North Rainier Landbanked Park Development
Seattle Design Commission March 5, 2020

11.21.19 Design Commission Comments on Preferred Alternative

Park Site Plan

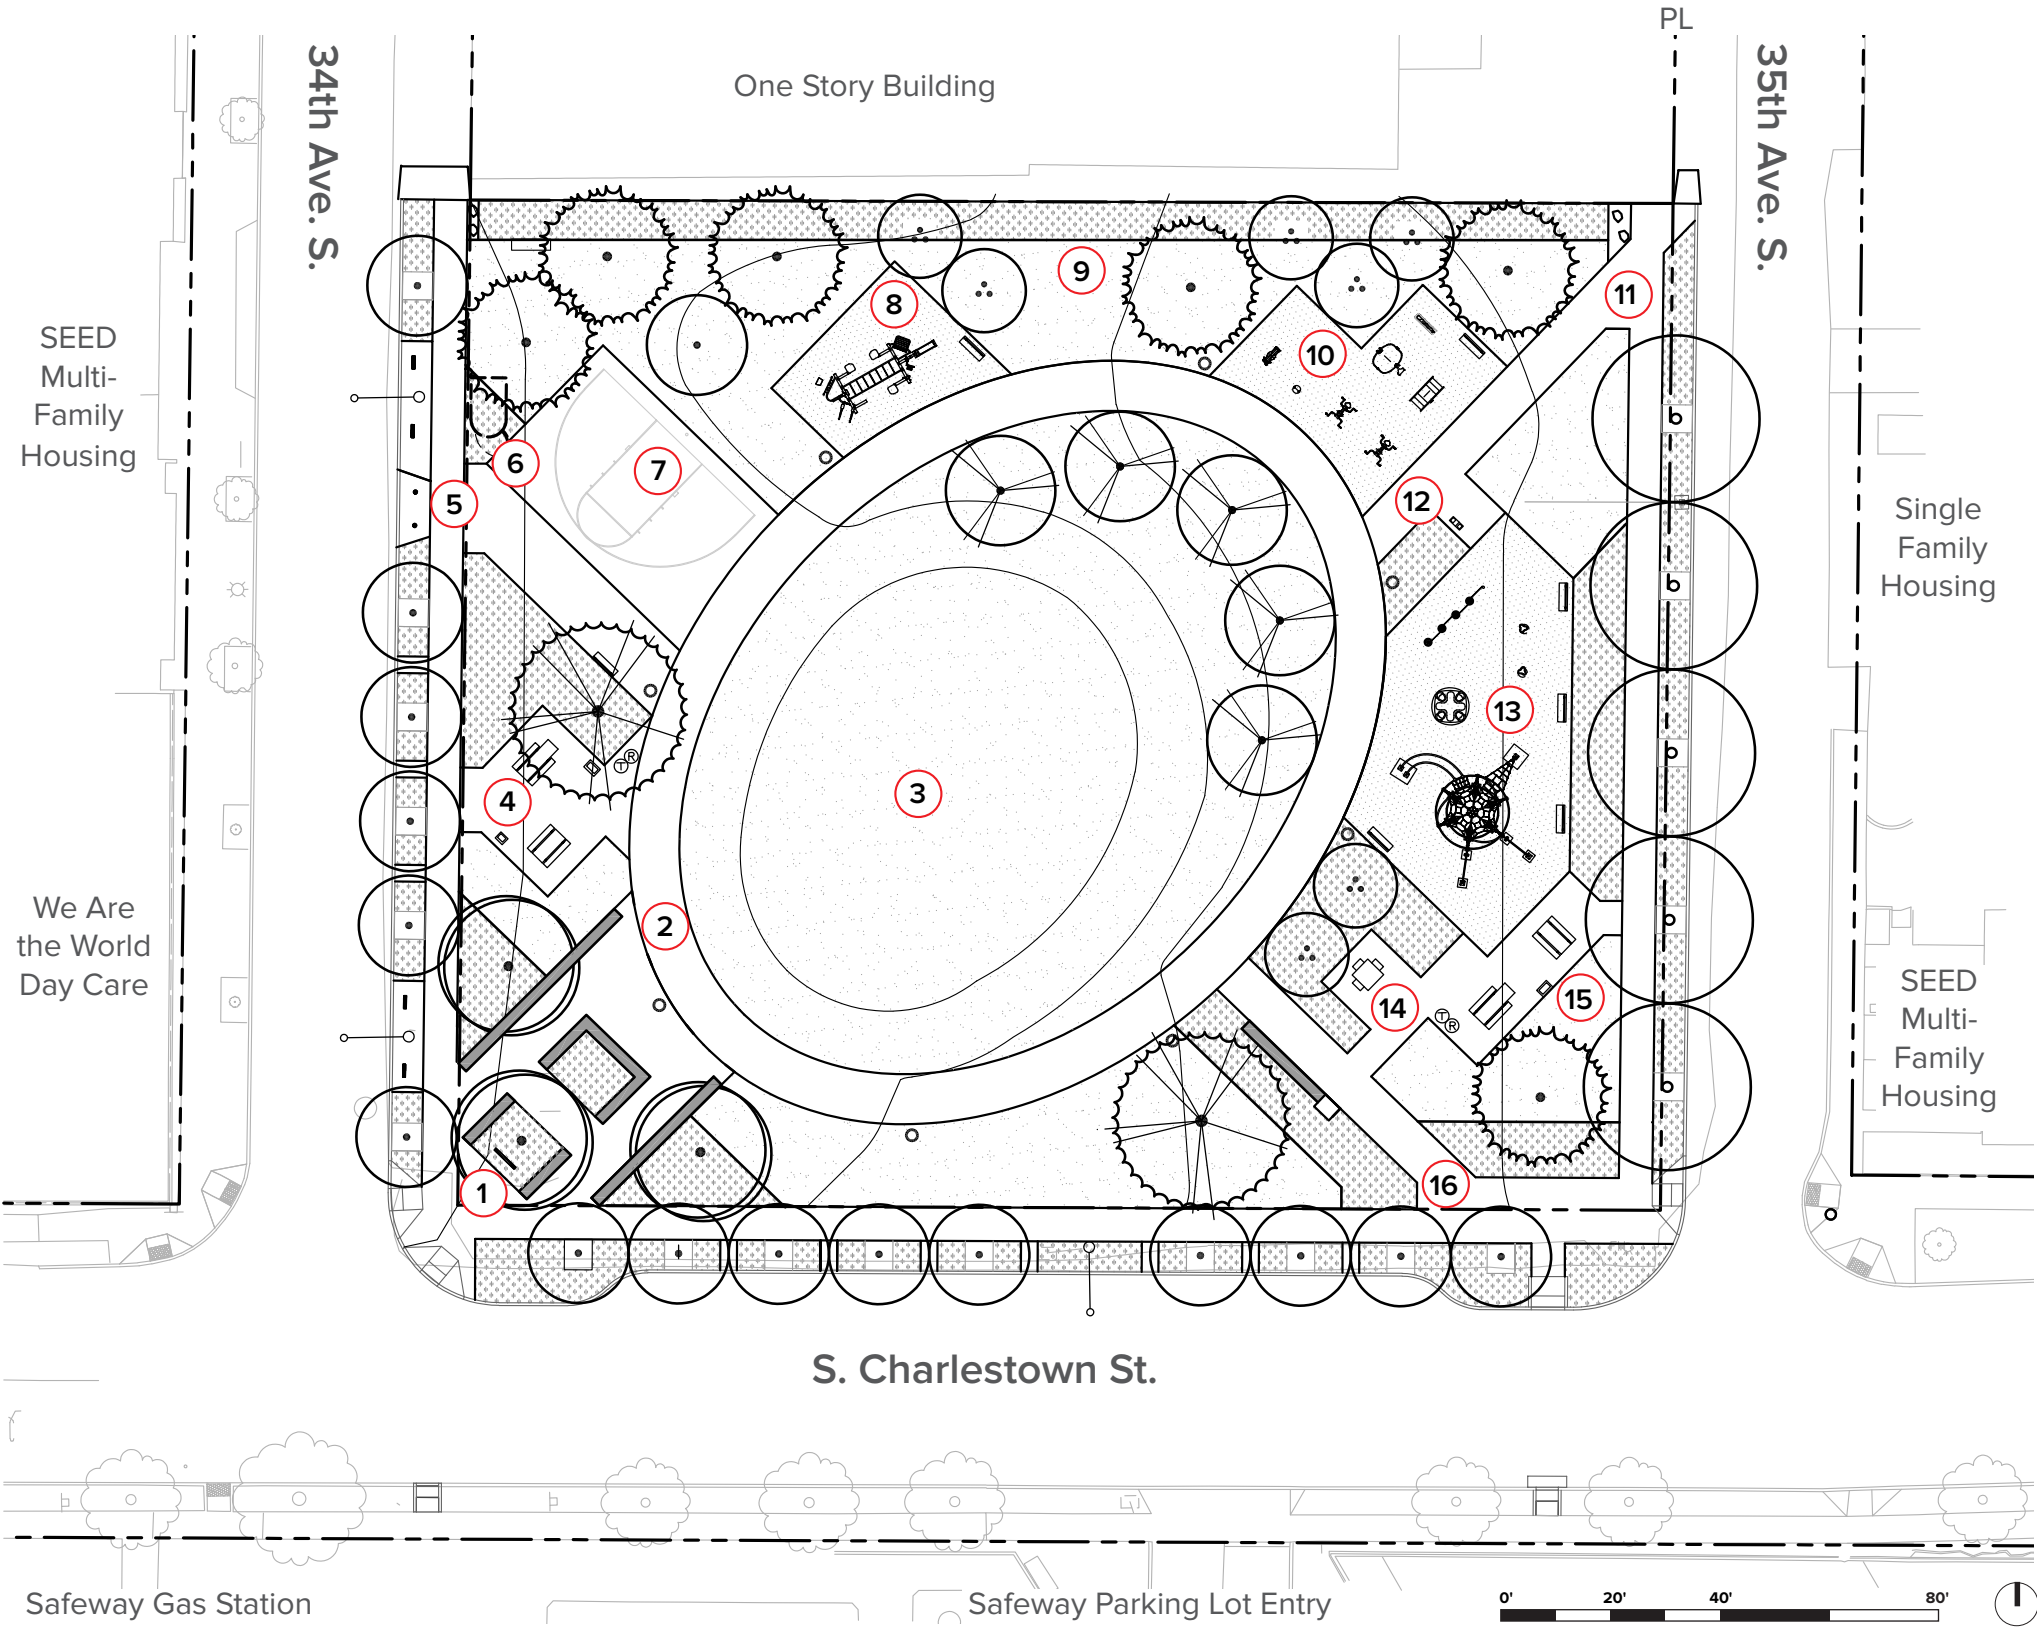
SDC Comments:

- A** Family Gathering
- B** Northern Edge
- C** Drinking Fountain
- D** Integration of Art + Culture
- E** Naming of the Park
- F** Cultural Elements in ROW
- G** Traffic Calming on Charlestown
- H** Sustainability for Site Furnishings

Right-of-Way

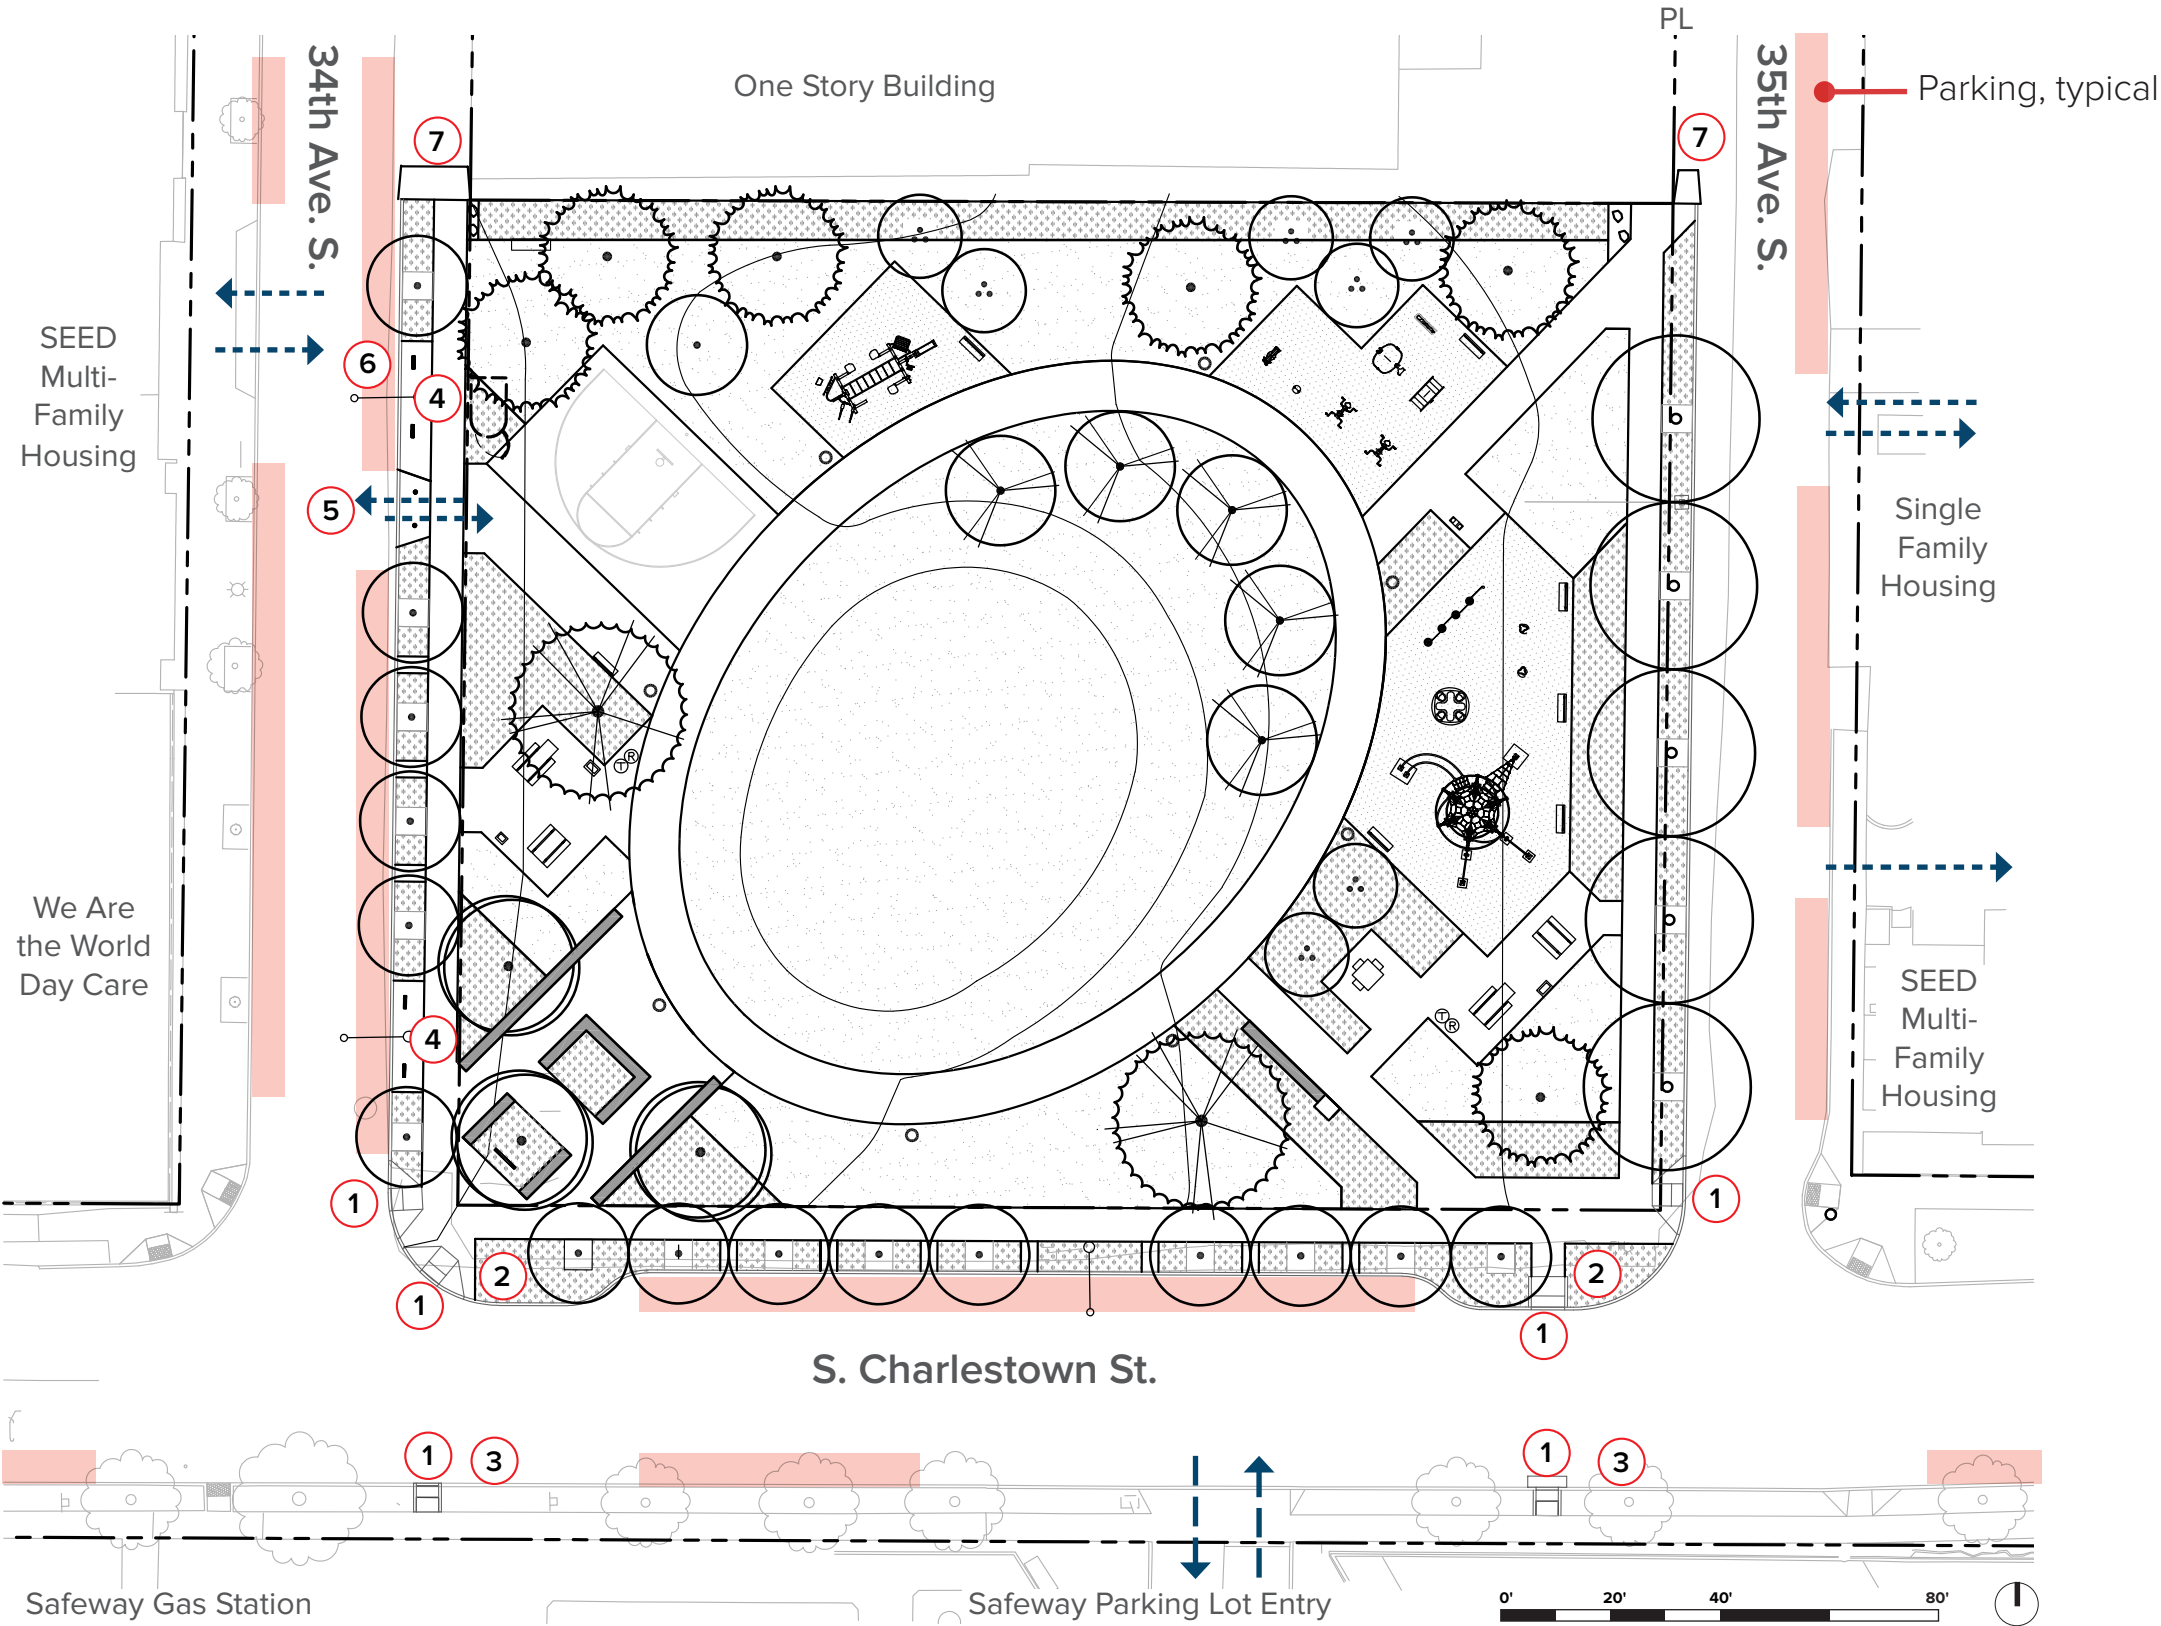
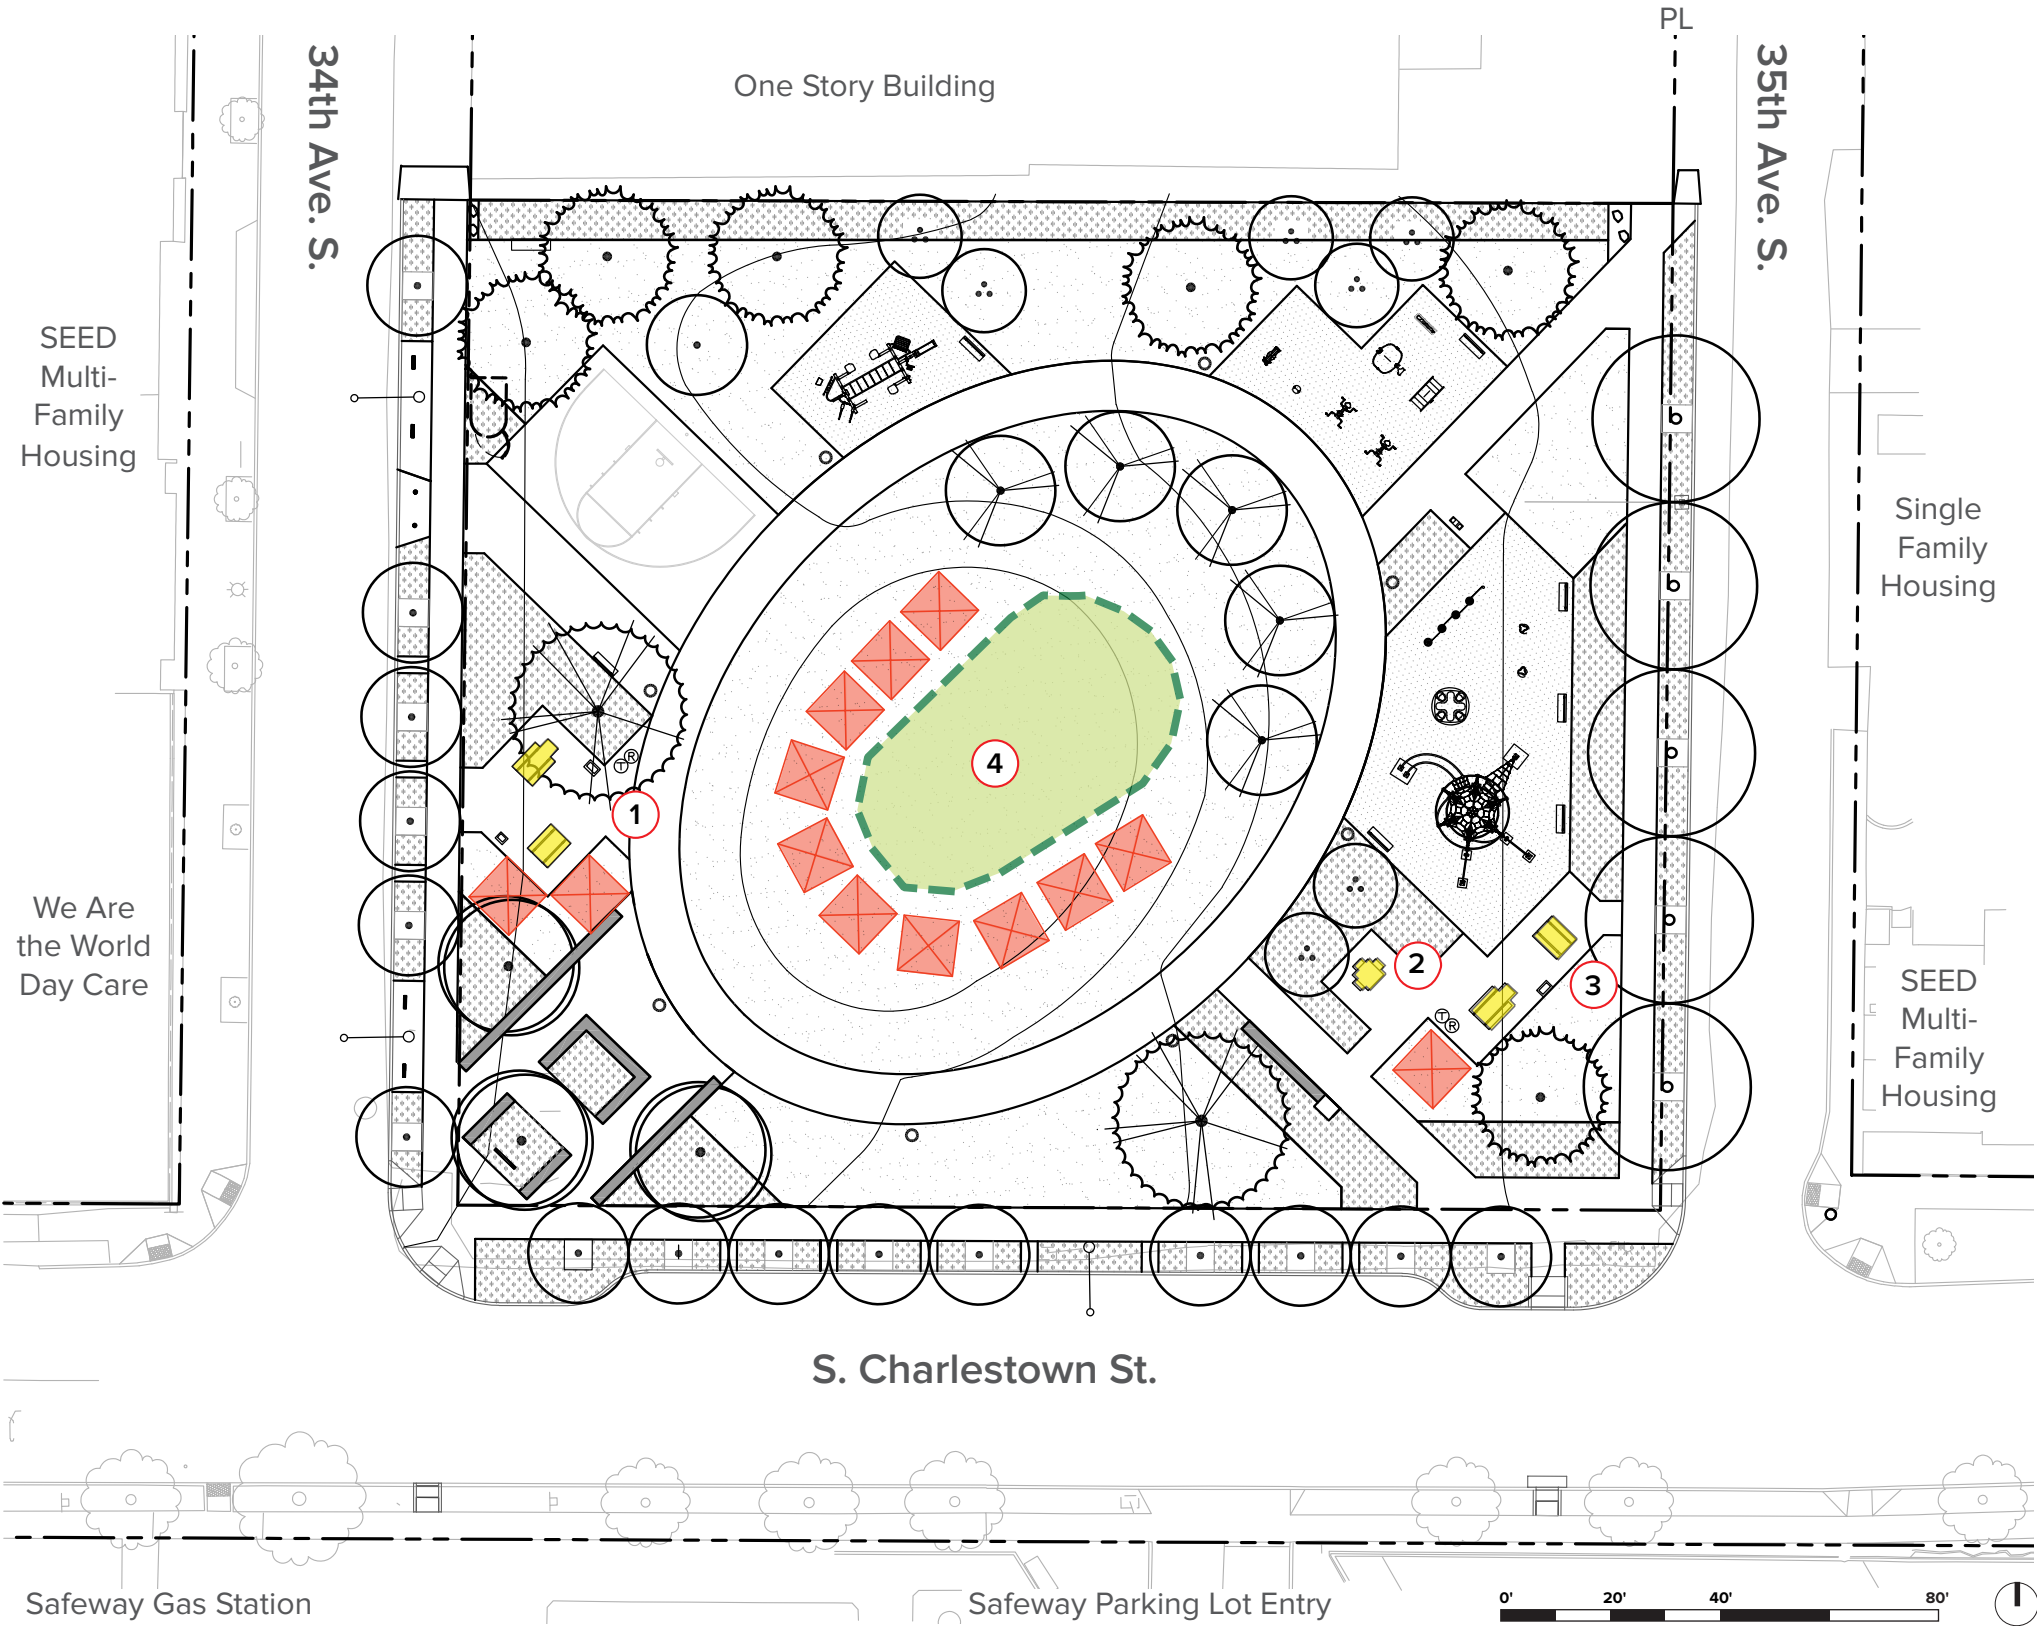
SDC Comments:

- F** Cultural Elements in ROW
- G** Traffic Calming on Charlestown

Proposed improvement on all street frontages include curb and gutter, a minimum 5.5' planting strip with street trees and understory, and a minimum 6' sidewalk.

Curb bulbs on both sides of S Charlestown Street provide traffic calming and connect to the commercial core. SDOT will fund curb bulbs on the south side of the street as part of this project (in development).
